APPLICATION NO.	FILING DATE	FIRST NAMED INVENTOR	ATTORNEY DOCKET NO.	CONFIRMATION NO.
10/758,194	01/16/2004	Cam Beatty	388.0002	4901

Office Action Summary	Application No. 10/758,194	Applicant(s) BEATTY ET AL.	
	Examiner Mark A. Deuble	Art Unit 3651

DETAILED ACTION

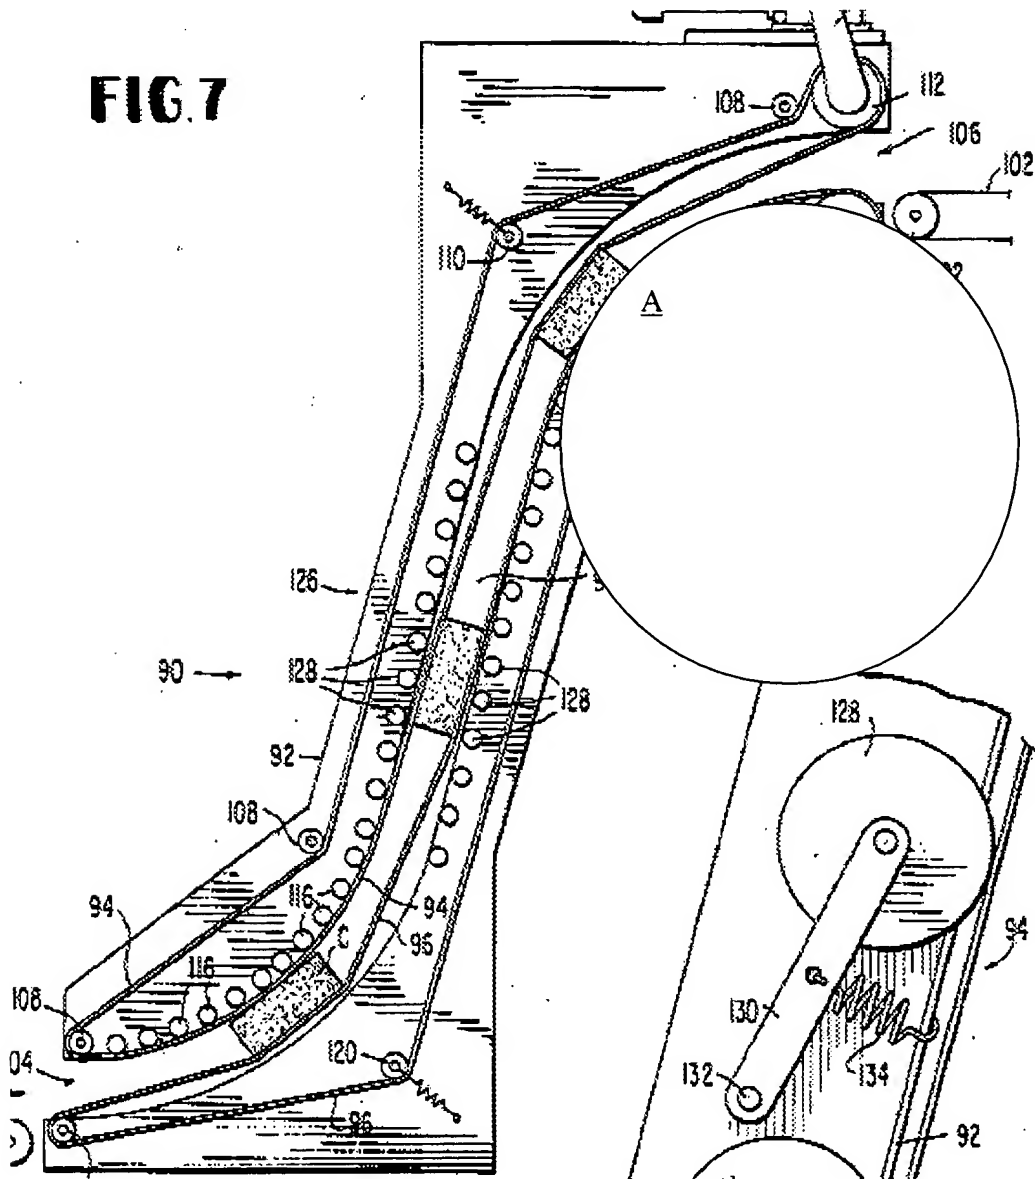
Hurd shows generally all the structure required by the claims except for cylindrical guide elements required by claims 6-7 and 10. Instead of large cylindrical guide elements, Hurd utilizes a plurality of small rollers to form large curves in the transport path. However, The British document teaches that a plurality of small guide rollers 26 may be used interchangeably with one large guide roller 16 as they are art recognized functional equivalents. Therefore it would have been obvious to one of ordinary skill in the art at the time of the invention to replace the small rollers 116, 124 of Hurd with large cylindrical rollers as taught by the British document. When this is done, the rollers would form first and second main guide elements that

are separated by a select distance and that are generally cylindrical with substantially equivalent diameters. Furthermore, the vertical distance separating the inlet and outlet would correspond to the sum of the diameters of the first and second guide elements and the distance separating them. Furthermore, because the first conveying element would contact approximately 90° of the circumference of the large guide roller replacing the guide rollers 124 and because the curve defined by these rollers 124 appears to cover approximately $\frac{1}{4}$ of the vertical distance between the inlet and the outlet, the diameter of the main guide roller would cover approximately half the

vertical distance between the inlet and the outlet (see the roller R added to the figure below).

Furthermore, because the curvature of the large roller would be equivalent to that of the rollers it replaces, the roller would have a low bending force on the object being conveyed to avoid

damaging the object. Thus, when Hurd is modified according to the teaching of the British document, it would have all the structure required by claims 6-7 and 10.
